RE: Qual. Test P&I
LIGO QUALIFICATION TEST
FACILITY
930212 File #2.2.5

OPTIONAL PUMPING SYSTEM FOR THE QUALIFICATION TEST

P & I DIAGRAM
 VACUUM SYSTEMS
 QUALIFICATION TEST
 UGO PROJECT
 CALTECH

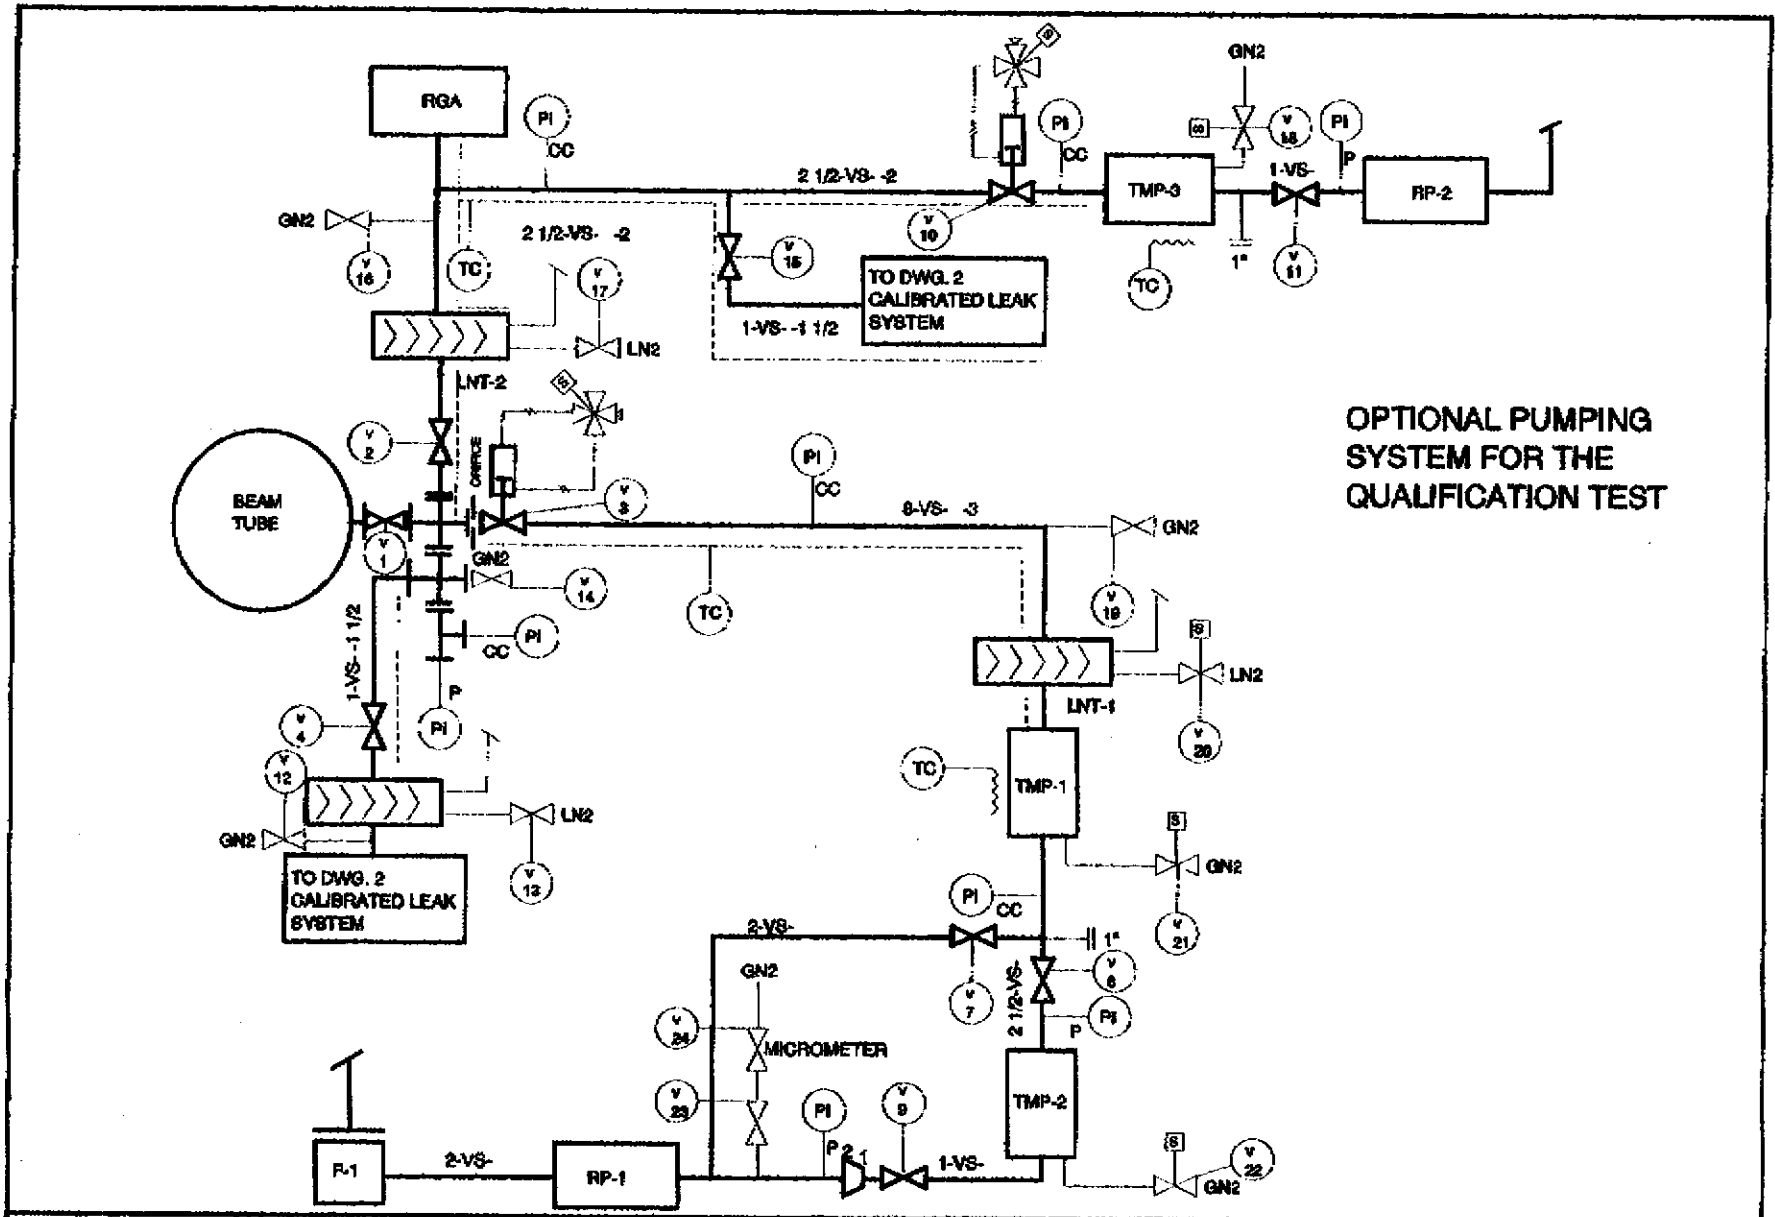
Attached is a P&I of a revised pumping system for the RGA on the qual. test system which reduces the length of the 2 1/2 " line to 32 inches. In addition, the conductance of the system is somewhat larger than calculated because this distance includes the LN2 trap which has a large conductance. Please have Rai review this layout. We are trying to provide a good quality system but we are also trying to use the fittings that are already purchased in order to prevent a schedule change which would happen if we had to repurchase some of the fittings. The fittings (such as crosses and tees which are not in stock can take up to 3-4 weeks to receive).
